Comments on "Socket Conventions Reconsidered"  
-----

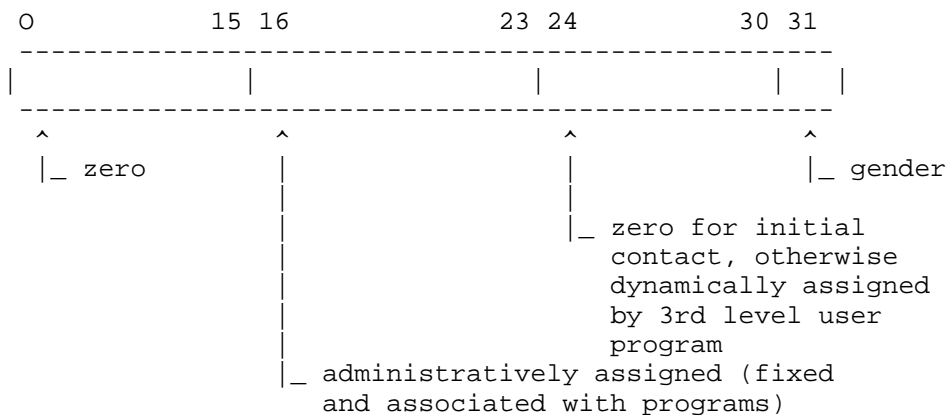
Our current use of socket names is diagrammed below.

(NOTE: This scheme corresponds exactly with both UCSB and UCLA/CCN conventions).
